# Groundwater Application Review Summary Form

Application # G- 18511

# MEMO

**To:** Kristopher Byrd, Well Construction and Compliance Section Manager  
**From:** Joel Jeffery, Well Construction Program Coordinator  
**Subject:** Review of Water Right Application G-18511  
**Date:** September 19, 2018

Figure 3. Water level data at nearby well, LINN 10817, show long-term stability in the alluvial aquifer.

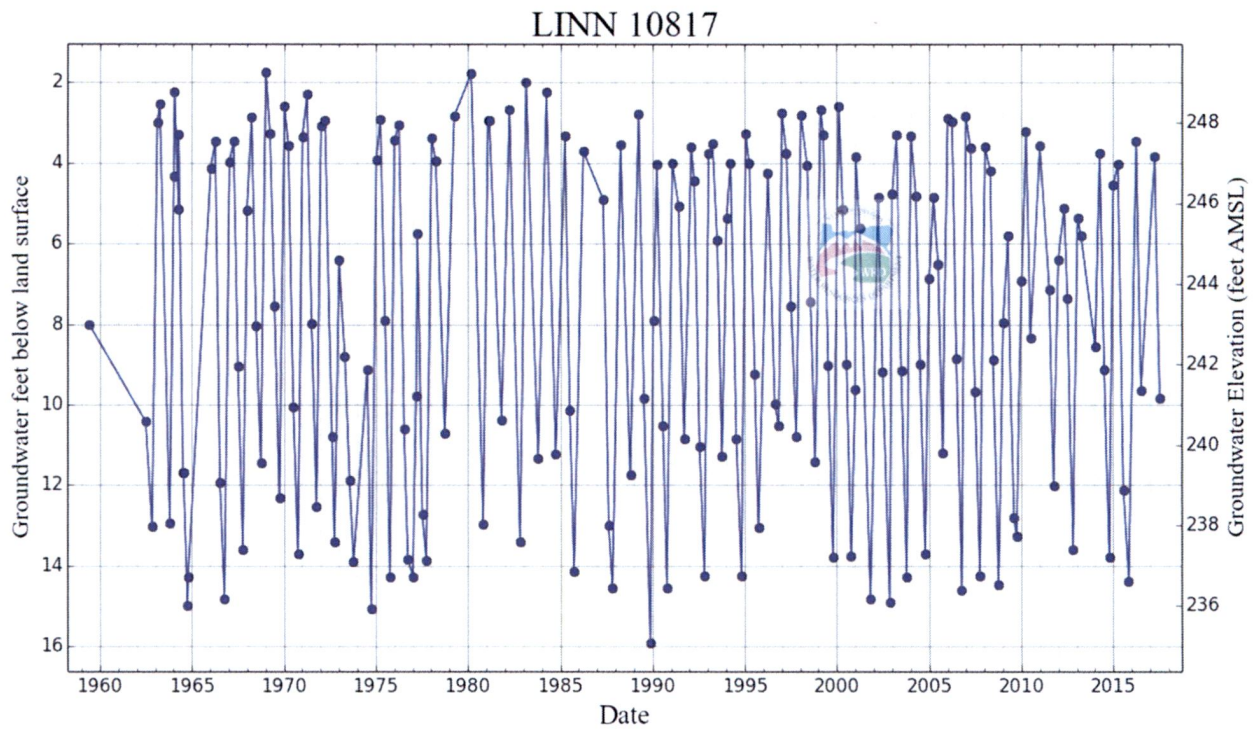
As shown in Figure 3, water level data from a nearby well (LINN 10817) show long-term stability.
